CITY SCHOOL DISTRICT OF ALBANY

# Albany High School – Phase 3 Board of Education Meeting

06.29.2020

# Exterior Design Proposed Changes

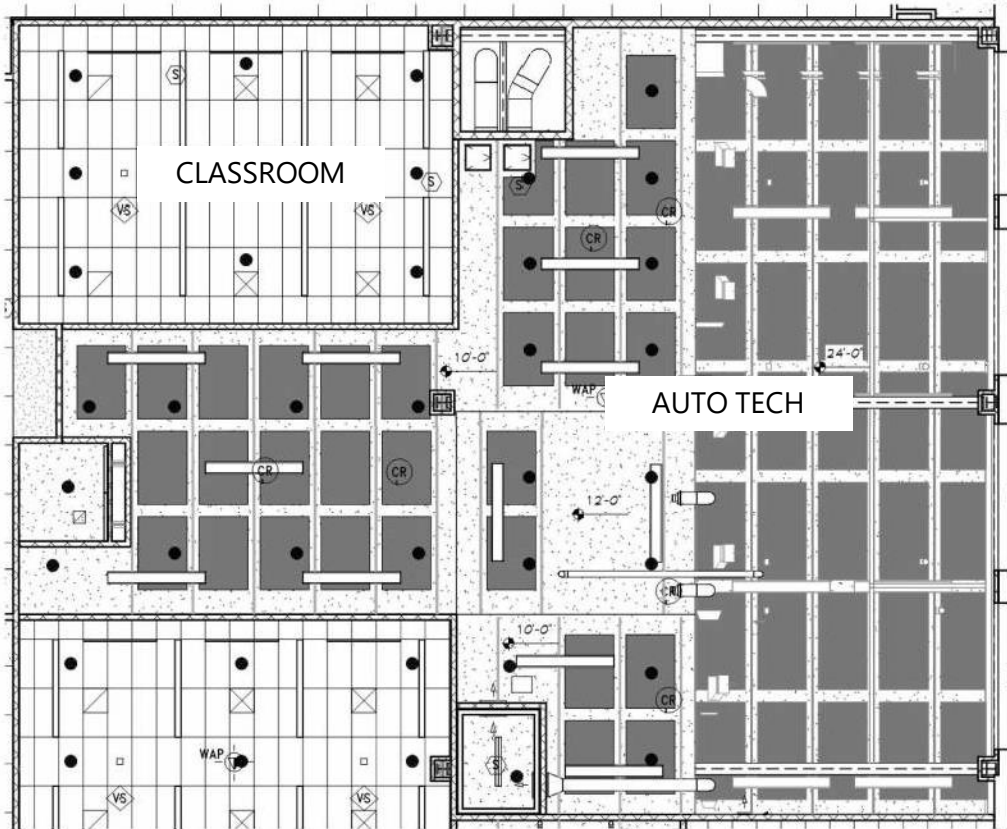
GLAZING REDUCED AT MAIN OFFICE, FULL-HEIGHT ACMU WALL SUBSTITUTED

GLAZING REDUCED AT MAIN OFFICE

GLAZING REDUCED AT THIRD FLOOR CORRIDOR

STOREFRONT REMOVED AT STAIR 3-1 EXIT DOORS, SUBSTITUTED WITH ACMU WALL and FRP DOORS

# CTE Auto Tech RCPs

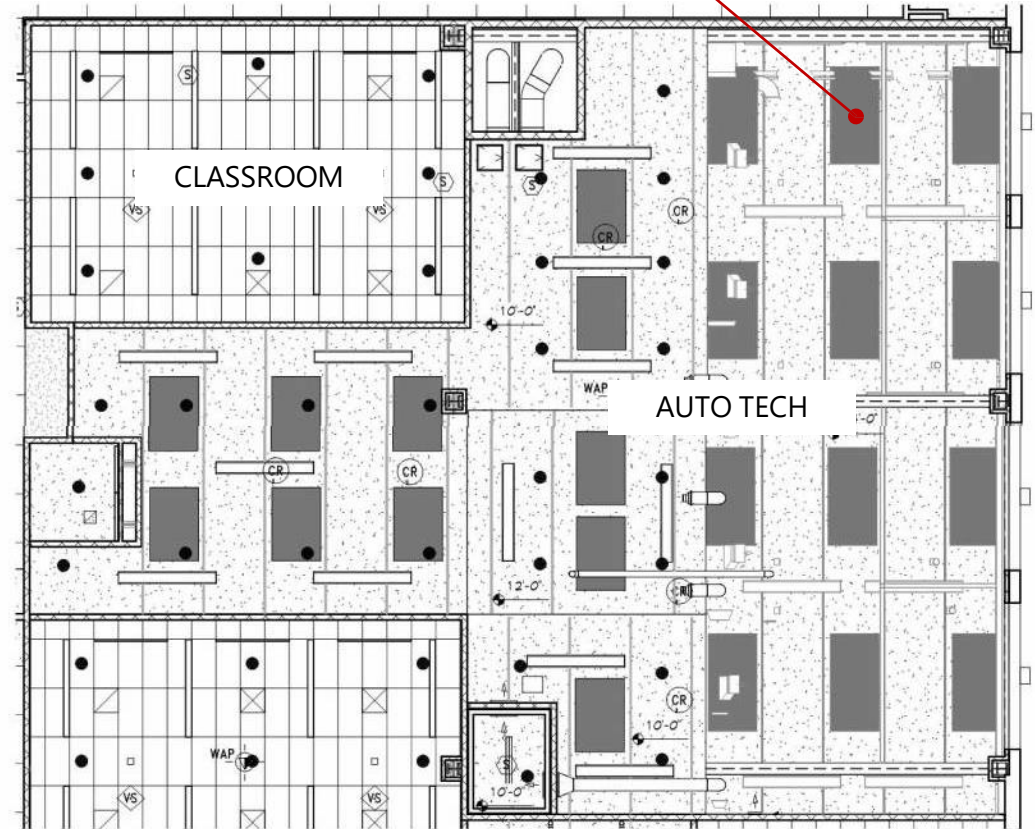
CEILING MOUNTED SOUND  
ABSORPTIVE PANEL, TYPICAL

CURRENT ACOUSTIC PANEL LAYOUT

PROPOSED ACOUSTIC PANEL LAYOUT

# CTE Building Trades RCPs

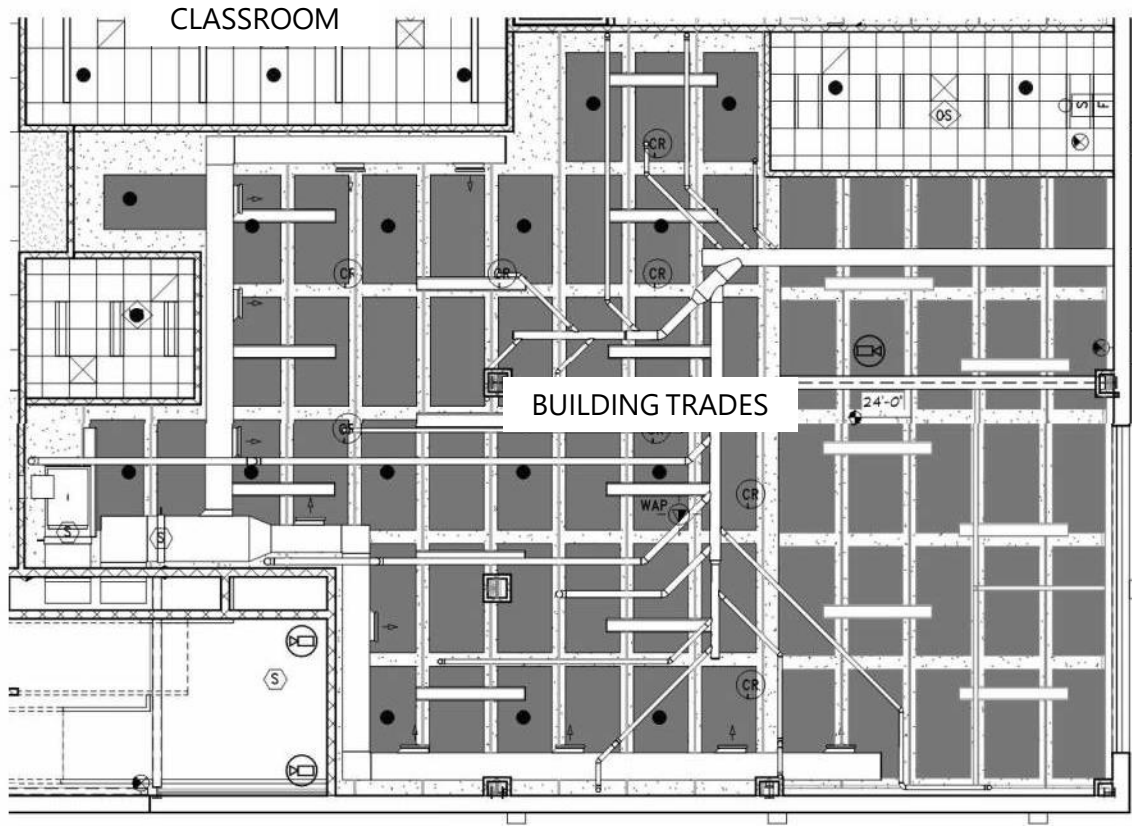
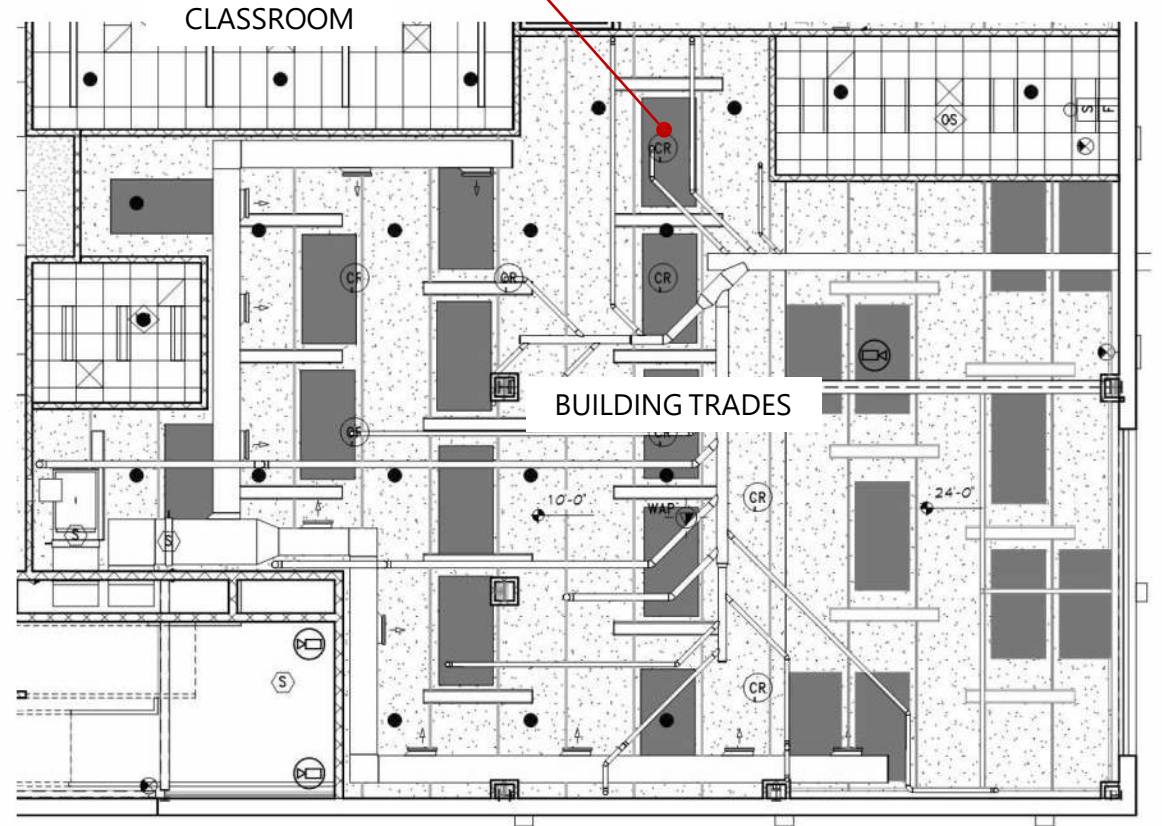
CURRENT ACOUSTIC PANEL LAYOUT

CEILING MOUNTED SOUND  
ABSORPTIVE PANEL, TYPICAL

PROPOSED ACOUSTIC PANEL LAYOUT

Media Center  
Bid Design

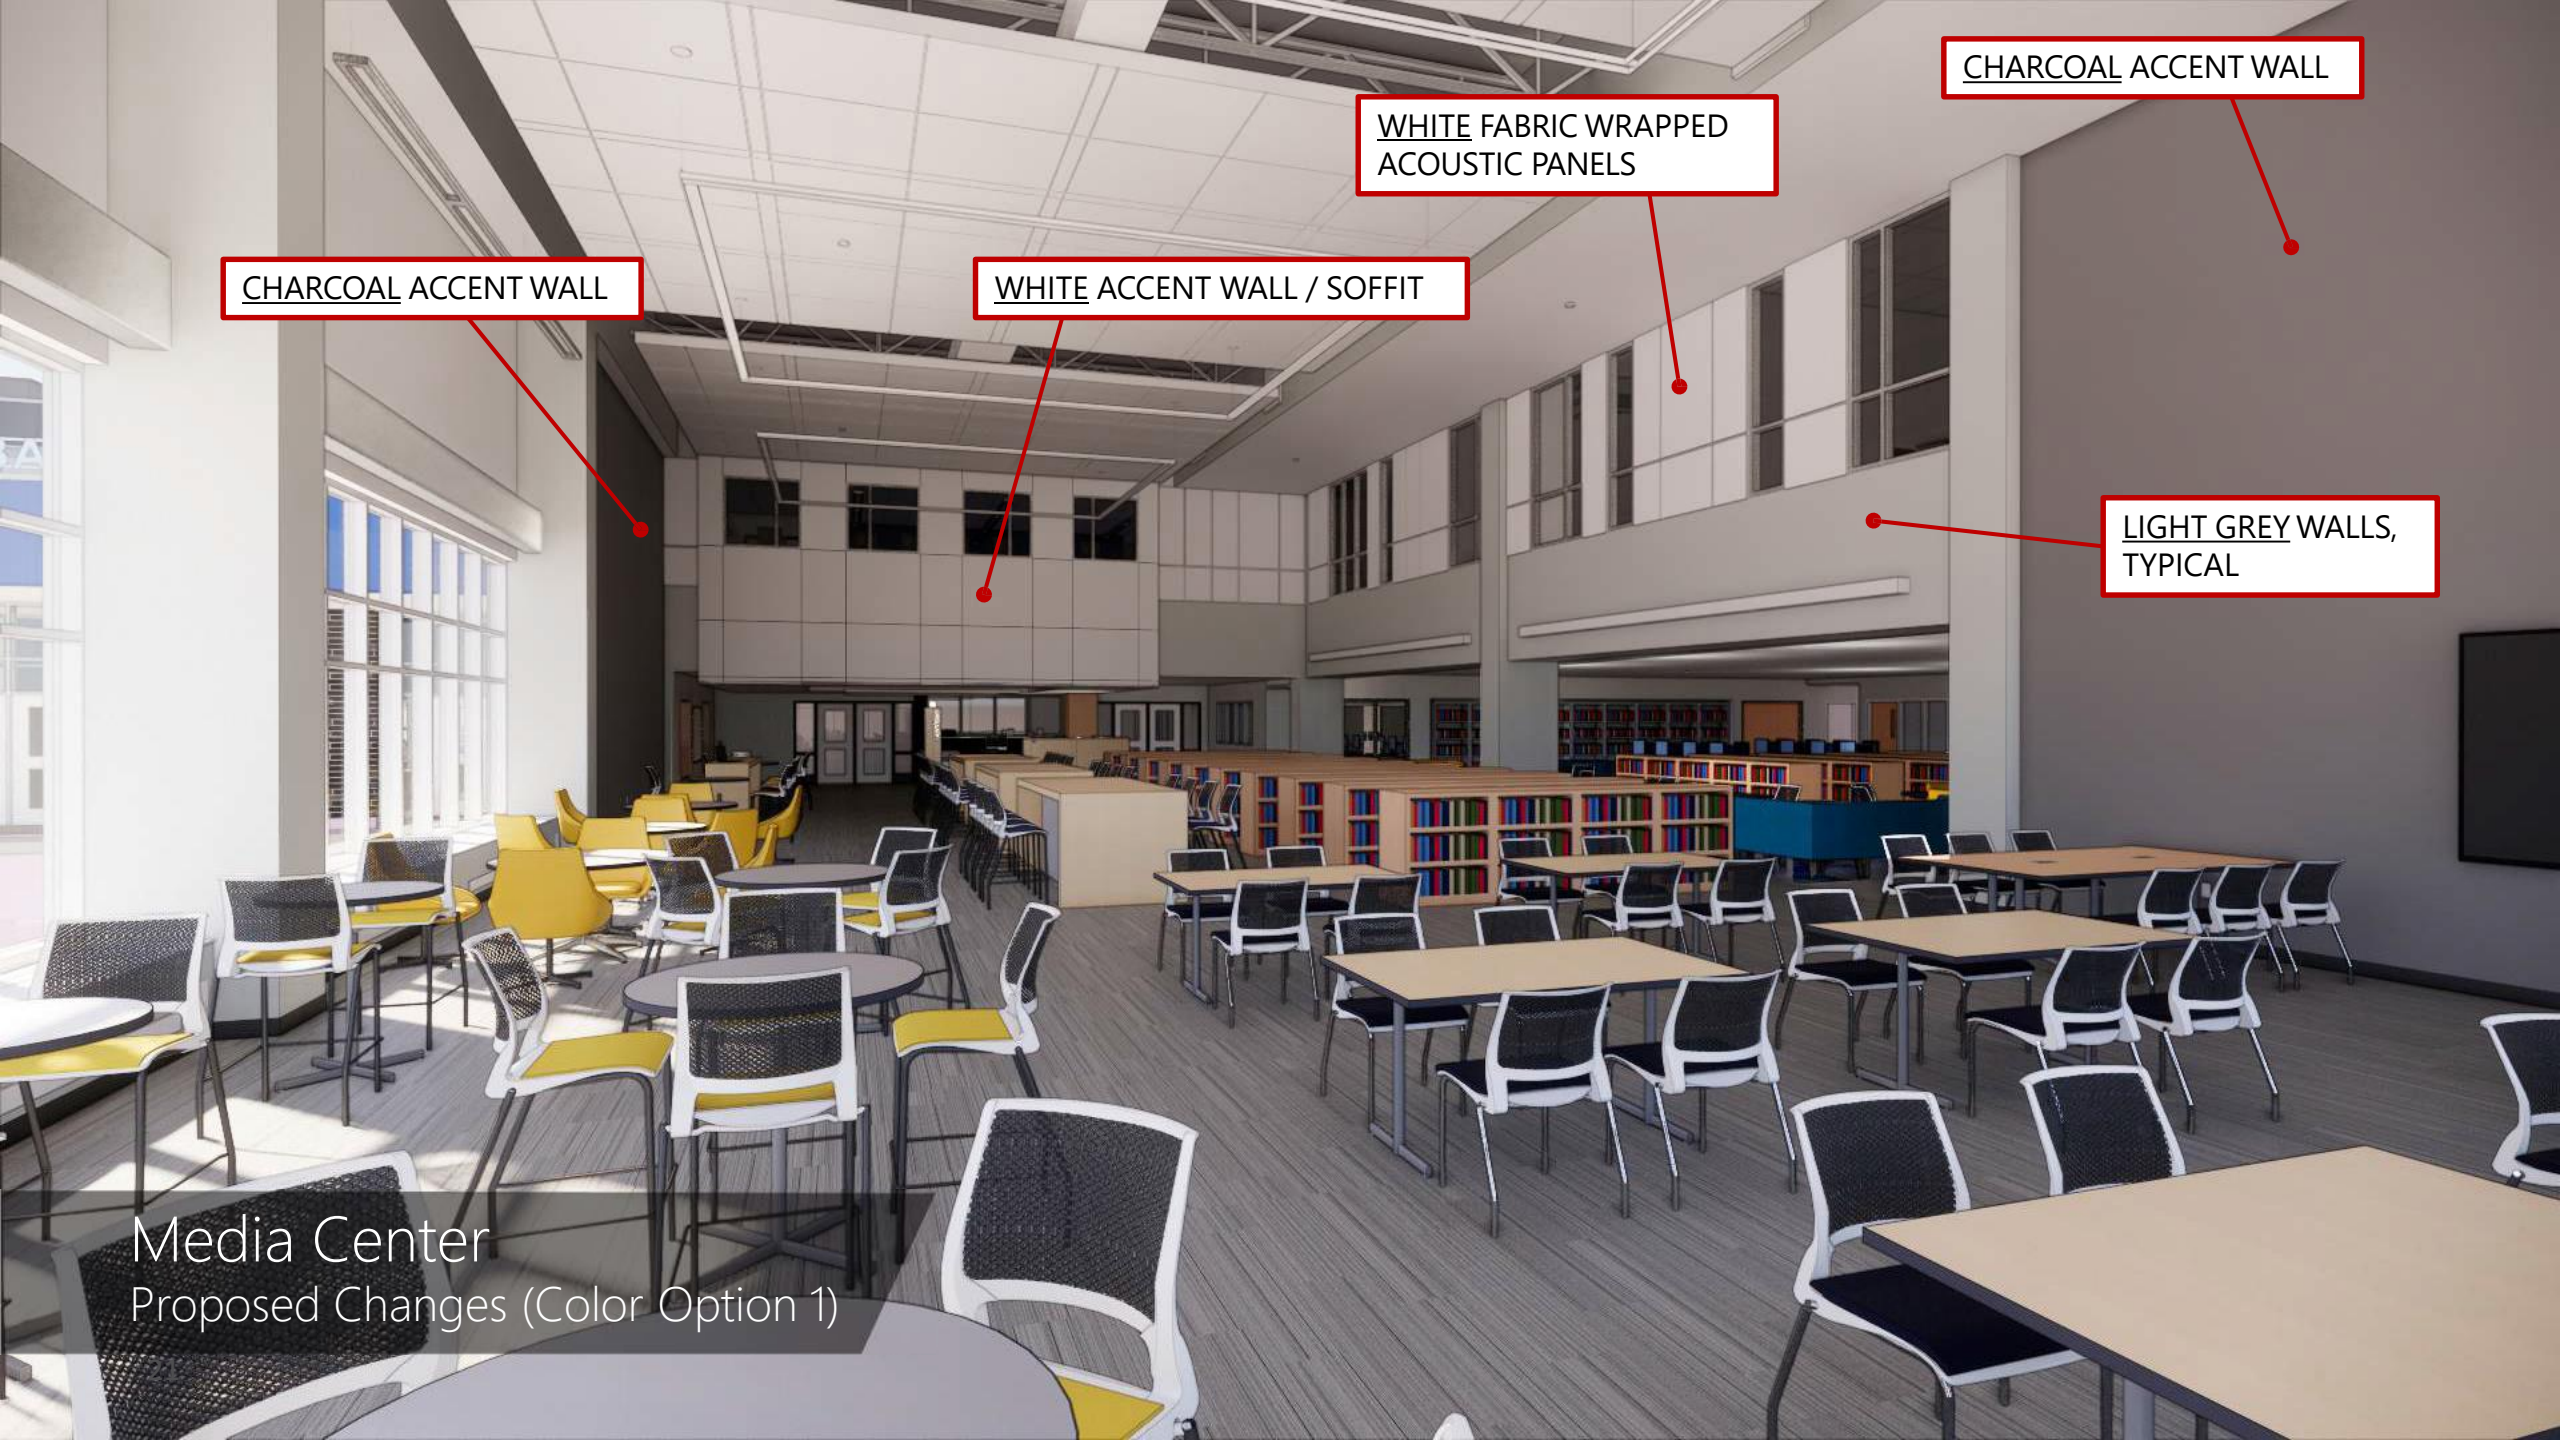
ANGLED CUSTOM ACOUSTIC  
PANELS REMOVED

WOOD VENEER FINISH REMOVED.  
ACCENT WALL and RETURN  
SOFFIT BELOW TO BE PAINTED  
(color options provided)

ANGLED CUSTOM ACOUSTIC  
PANELS REMOVED
